## Catalog error correction notice

### ■ Gearmotor/Reducer General Catalog

Induction gear motor F3S type (concentric right angle hollow bore) Shaft diameter 45 Flange mounting Page 420

<Figure 1>

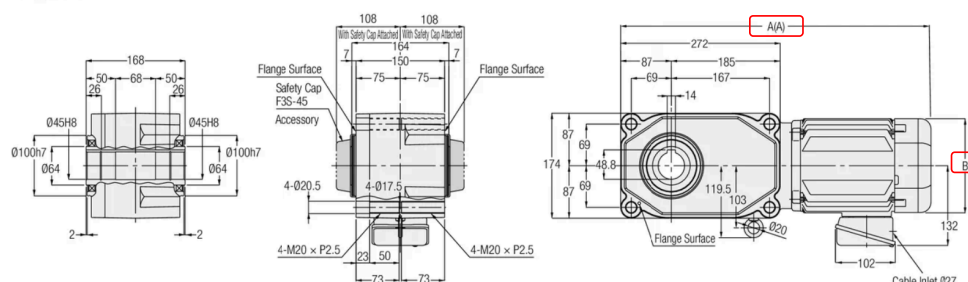
Incorrect: A (A)  
Correct: 508.5 (528.5)

Incorrect: B  
Correct: □156

<Figure 2>

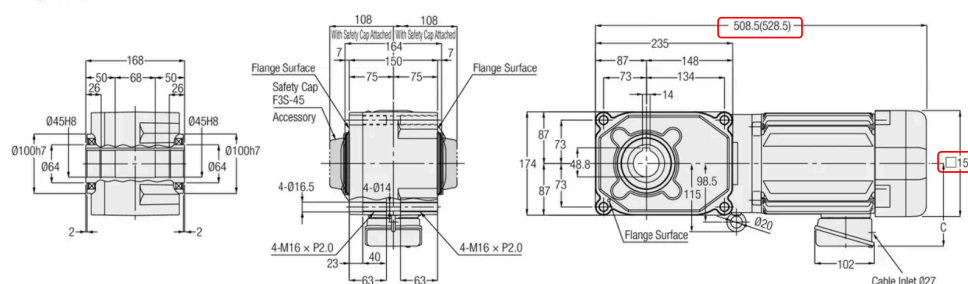
Incorrect: 508.5 (528.5)  
Correct: A (A)

Incorrect: □156  
Correct: B
